A d d e n d u m

Iowa Department of Transportation

B.O.	Proposal ID	Proposal Work Type	County	Project Number	Addendum
011	78-0293-069	BRIDGE REPLACEMENT - STEEL GIRDER	POTTAWATTAMIE	IM-NHS-029-3(69)53--03-78	20JUN011A03

Replaces plan sheets 2, 25, 26, J.01, and J.69 with the attached:

TRAFFIC CONTROL PLAN

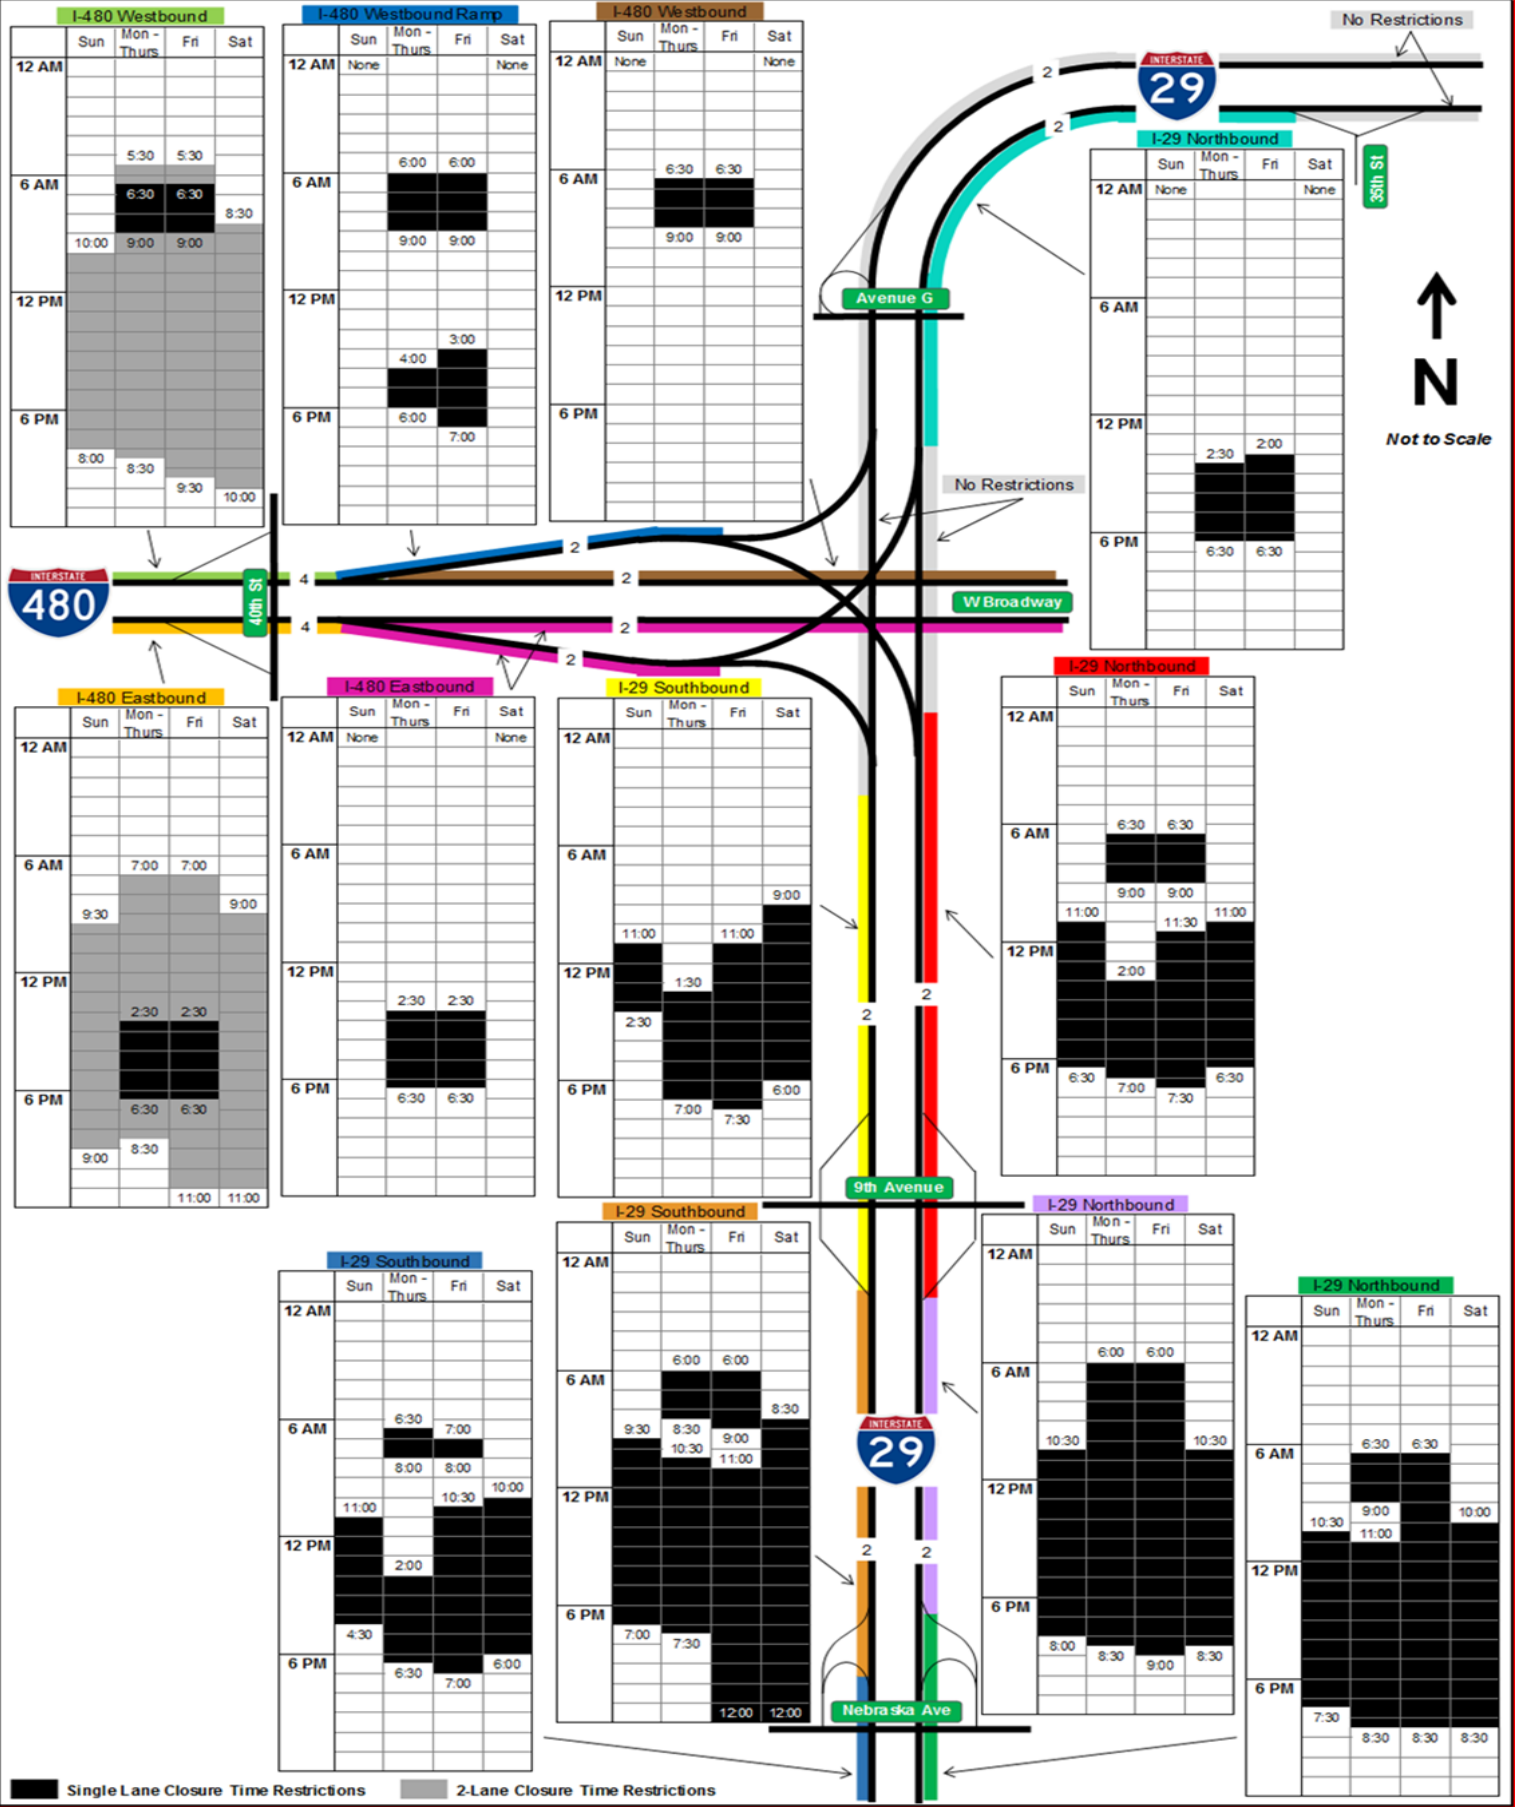
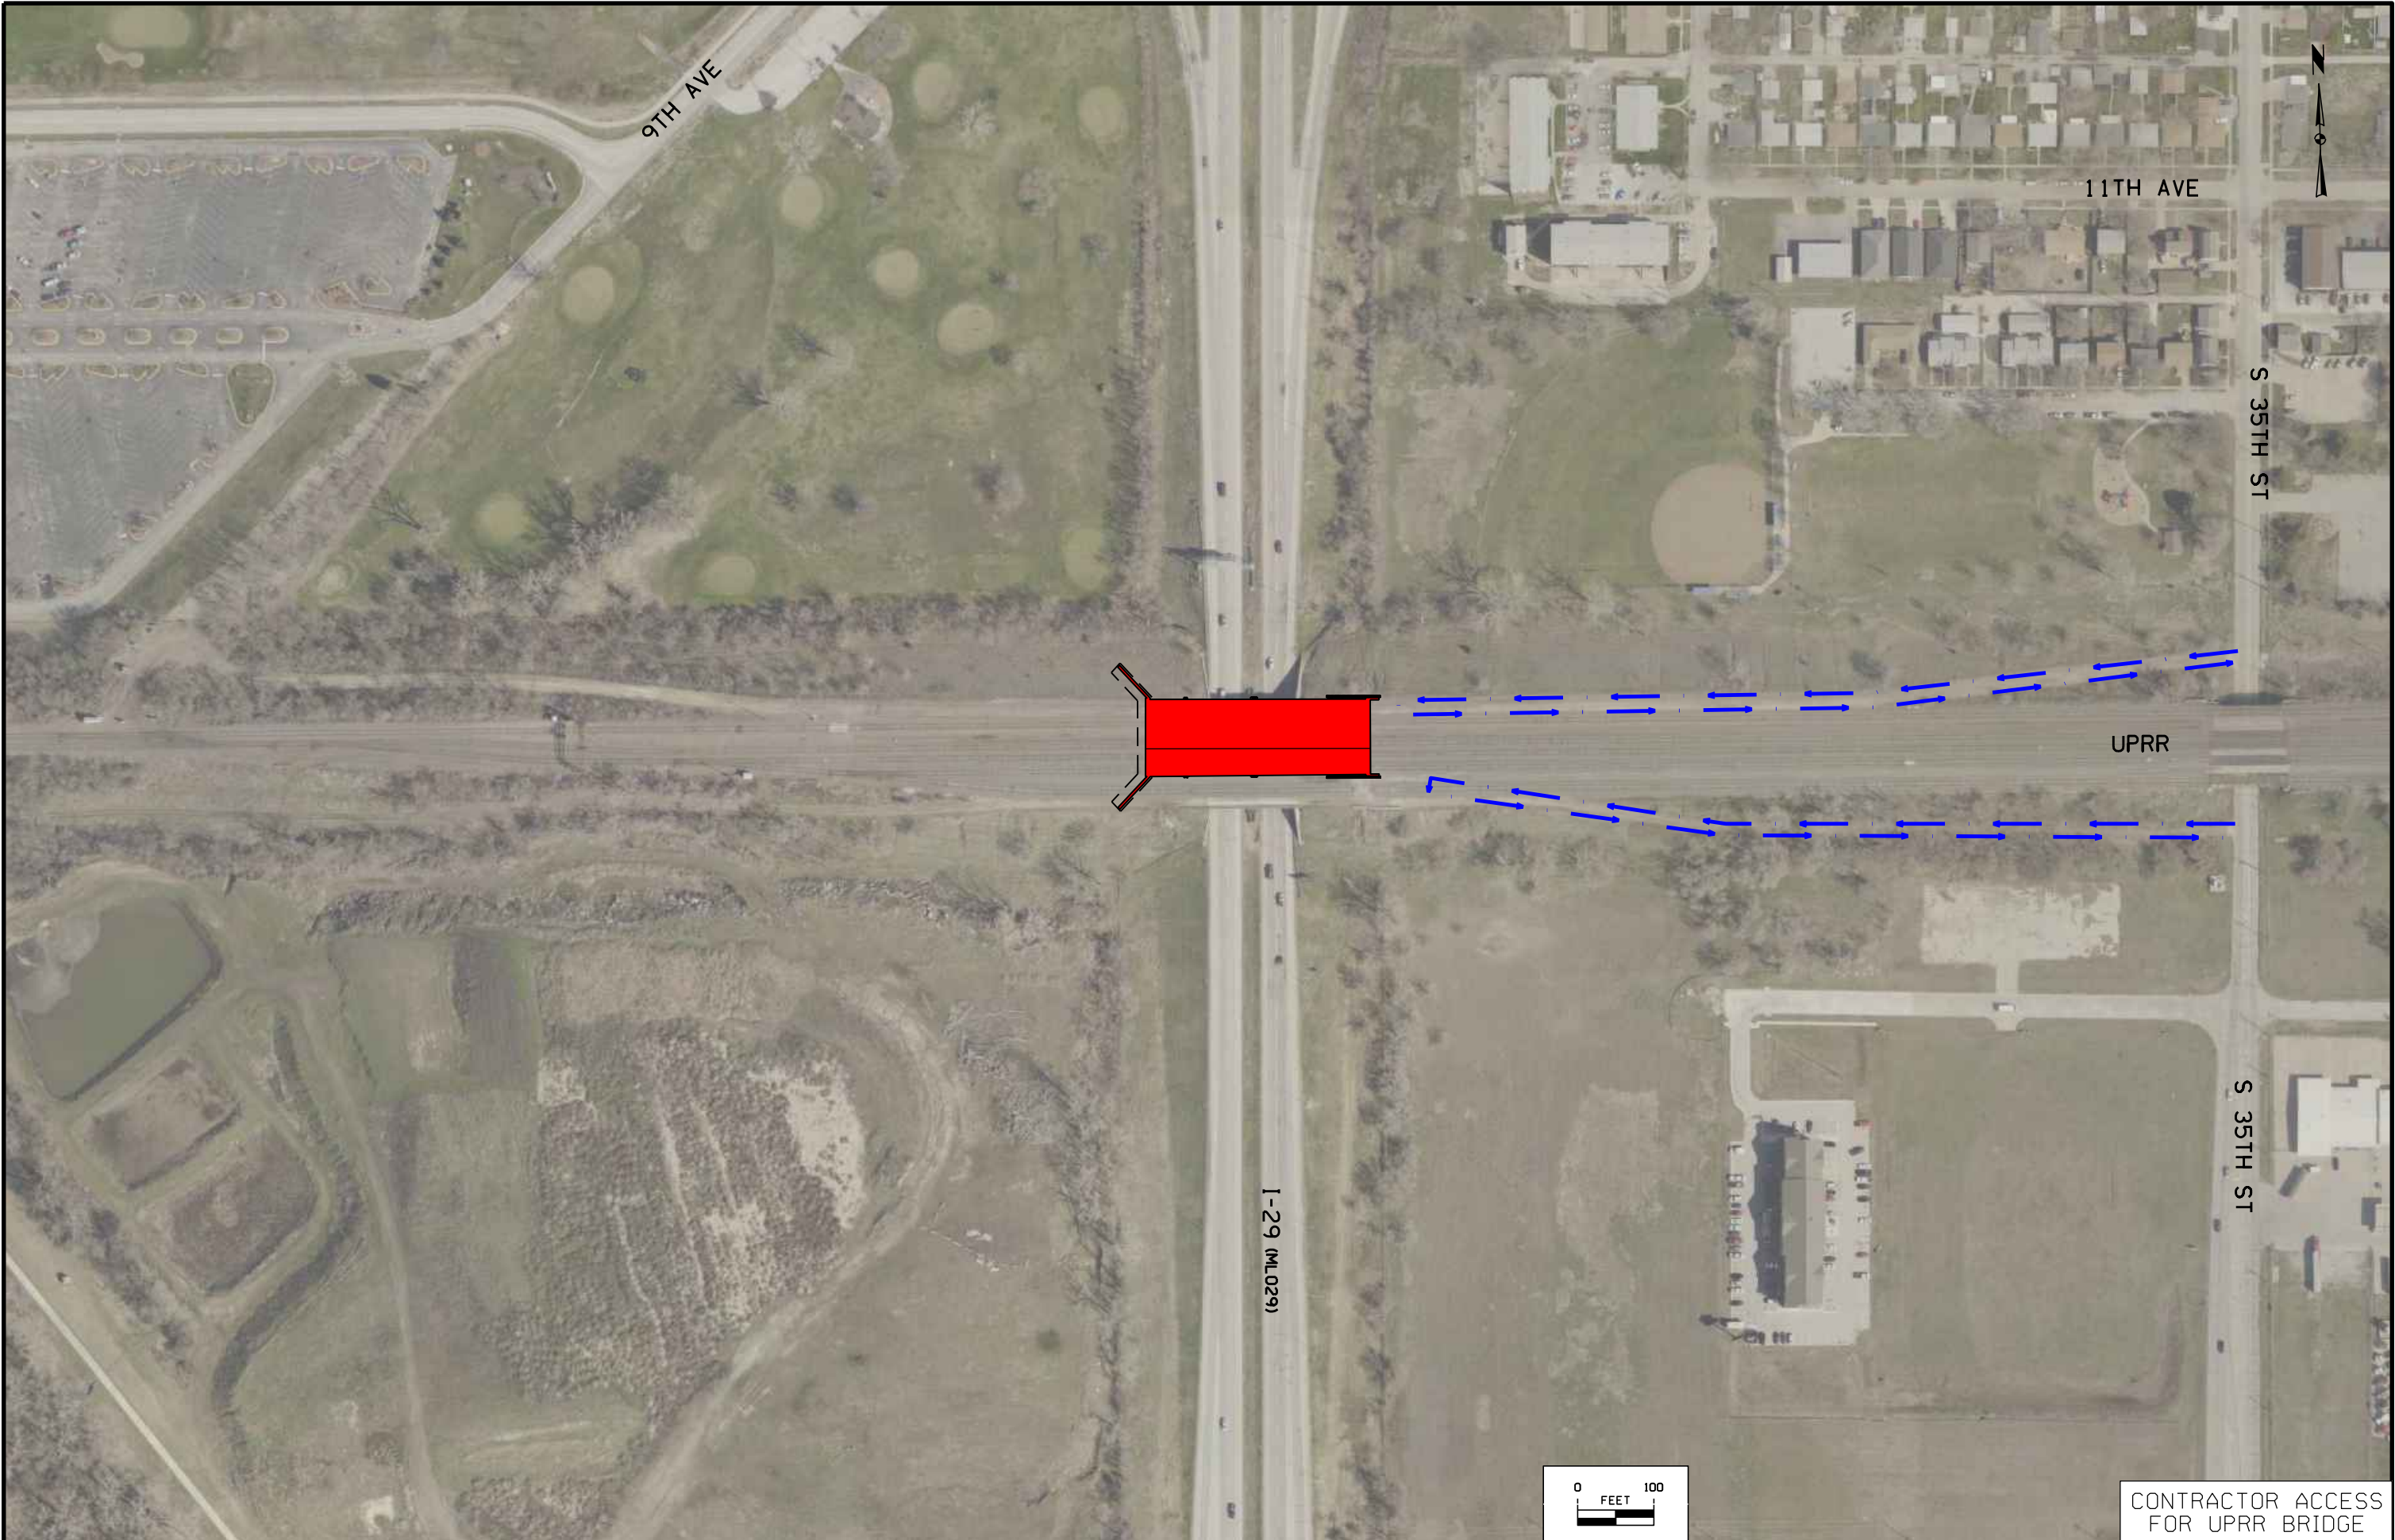
Sheet J.1 – Revised Traffic Control Plan note 1.A to delete sentence regarding full closure for consecutive days.
